WURLITZER

Electronic Piano Notes

Issued by Wurlitzer Service Dept., DeKalb, Illinois

CIRCUIT MODIFICATION TO PROVIDE PROTECTION FOR TRANSISTOR "TR-1"

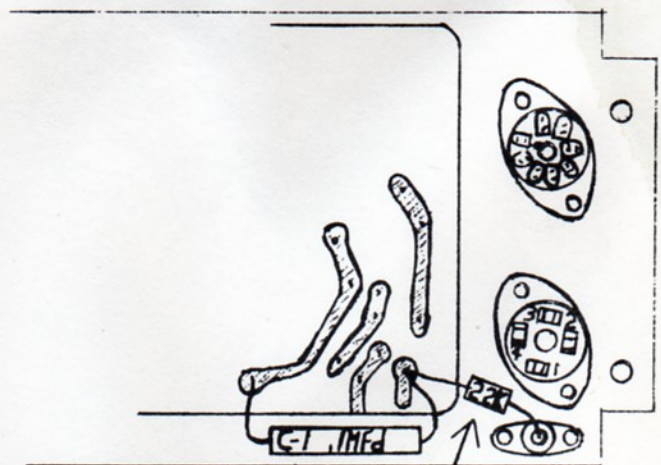
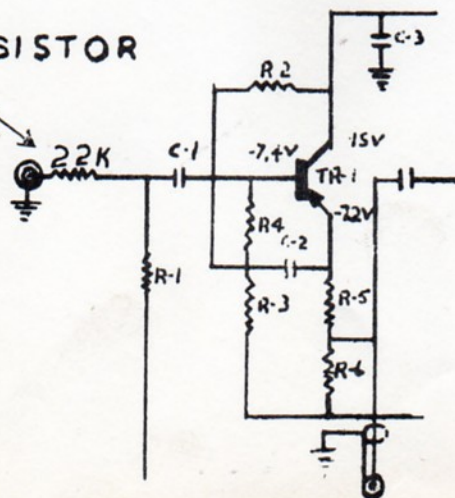
OCCASIONALLY, WHEN TUNING A REED OR SERVICING A REED BAR, AN ACCIDENTAL SHORT CIRCUIT, I.E., LEAD FILINGS, CAN OCCUR WHICH CAUSES A SPIKE PULSE TO SHOCK TRANSISTOR TR-1, RESULTING IN THE POSSIBLE FAILURE OF THE TRANSISTOR.

A 22K RESISTOR IS NOW BEING INCORPORATED BETWEEN THE INPUT PLUG AND C-1. WHENEVER SERVICING THE AMPLIFIER, WE SUGGEST YOU CHECK FOR THIS REVISION, AS ILLUSTRATED BELOW:

ADD THIS RESISTOR

ADD THIS RESISTOR

CIRCUIT MODIFICATION TO REDUCE HUM IN MODEL 145 AND 720 ELECTRONIC PIANOS

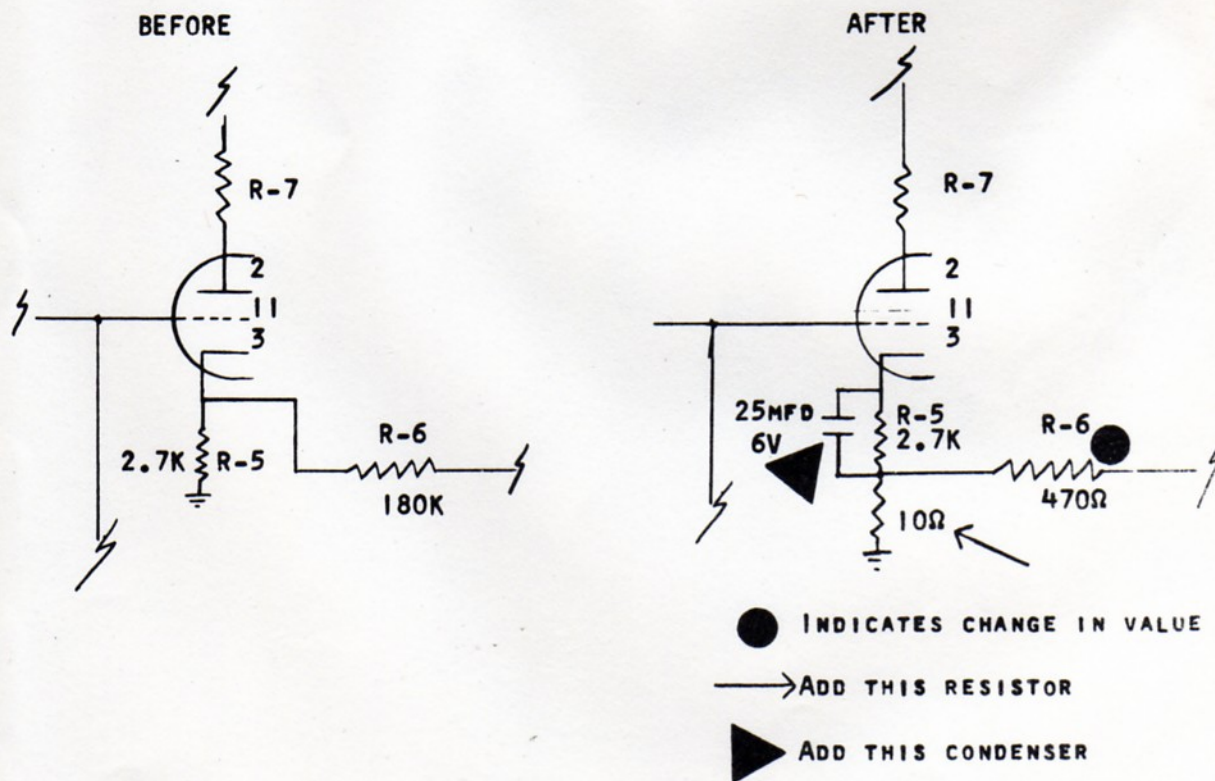
SHOULD YOU ENCOUNTER EXCESSIVE HUM IN MODEL 145 OR 720 ELECTRONIC PIANOS BELOW SERIAL No. 30856 (MODEL 145,) OR SERIAL No. 40401 (MODEL 720,) MAKE THE CIRCUIT MODIFICATIONS AS SHOWN BELOW:

ONE	25MFD, 6 VOLT ELECTROLYTIC CONDENSER
ONE	10 OHM, 1/2 WATT RESISTOR
ONE	470 OHM, 1/2 WATT RESISTOR

MODEL 930 ELECTRONIC PIANO AUXILIARY AMPLIFIER TRANSISTOR FAILURE

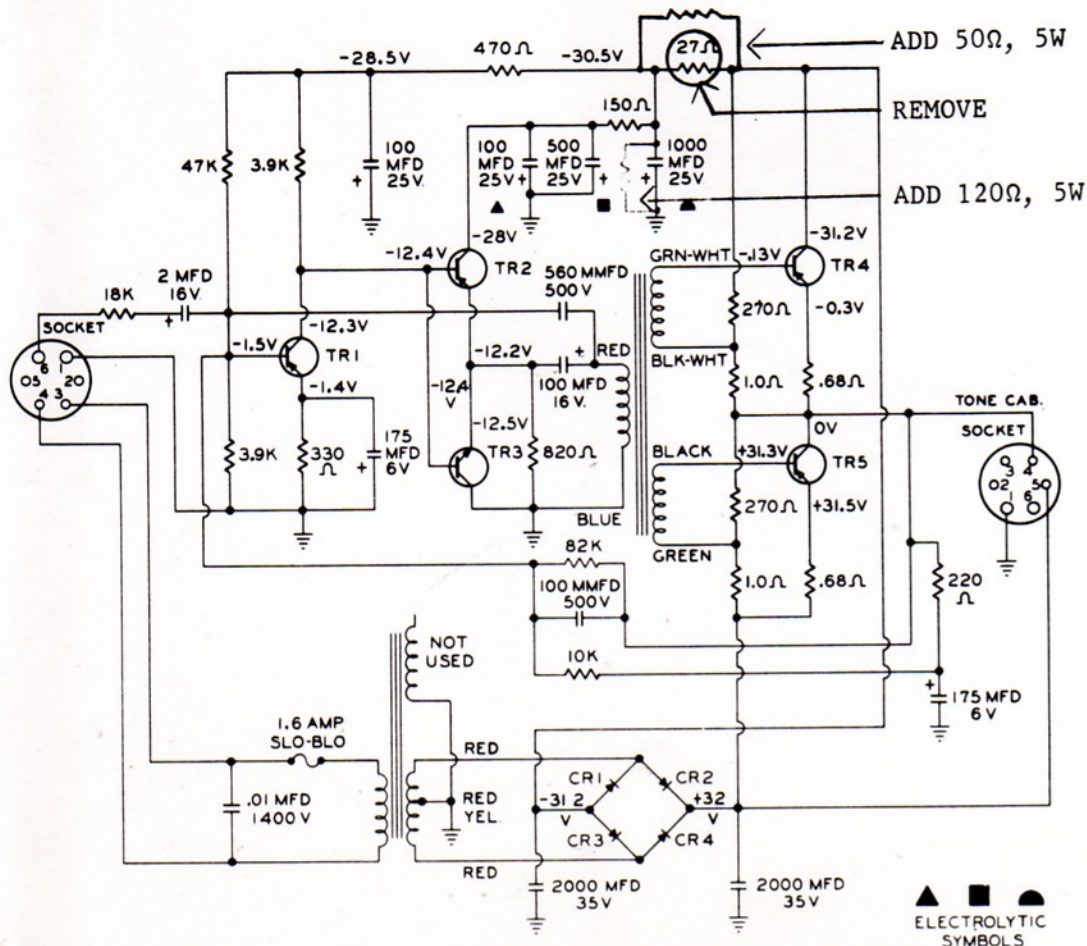
Should transistor failures be encountered in the Model 930 Electronic Piano Auxiliary Amplifier, it is suggested that one resistor be changed, and another resistor added to provide closer voltage regulation of the power supply. (Please refer to the schematic below and note the items in red.)

The transistors most likely to be affected by this change will be TR-2, TR-3, TR-4, and TR-5.

1. Remove the 27Ω resistor.
2. Replace with 50Ω, 10%, 5-watt resistor, (Part #74818-2).
3. Add 120Ω, 10%, 5-watt resistor (Part #74821-2) at point indicated.

DIAGRAM OF THE BACK OF
A TEN PIN MALE SOCKET (TOP VIEW)

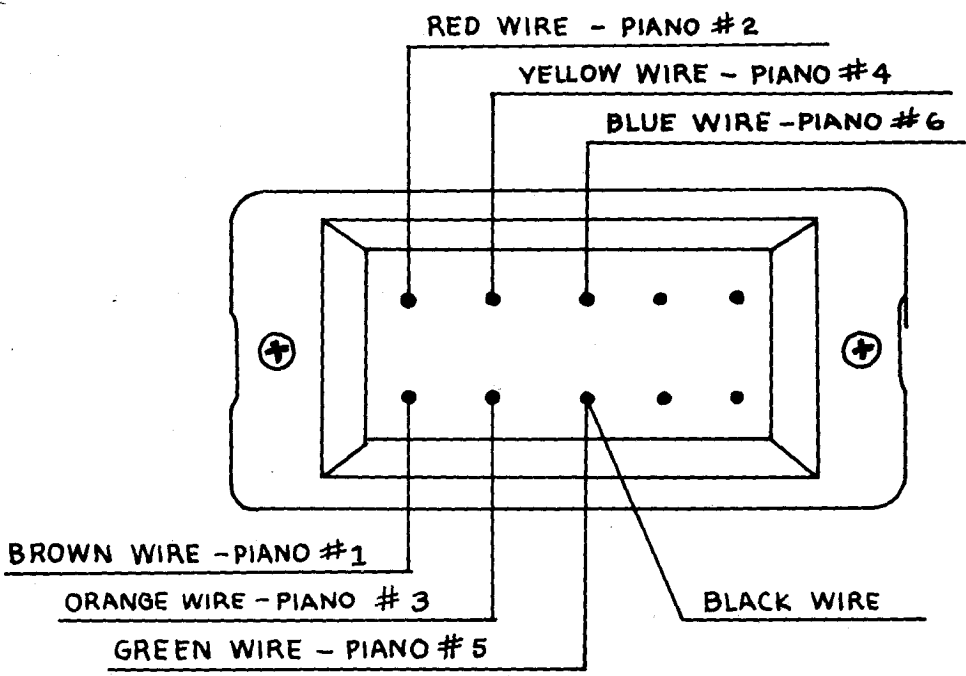
STEP 3: To change the communication number of the piano remove the black wire and solder it to the desired terminal for the new number.

The terminal at which the black wire, in addition to the colored wire, is soldered will determine the number of that particular piano. For example, by soldering the black wire to the terminal with the green wire -- the piano becomes a #5.
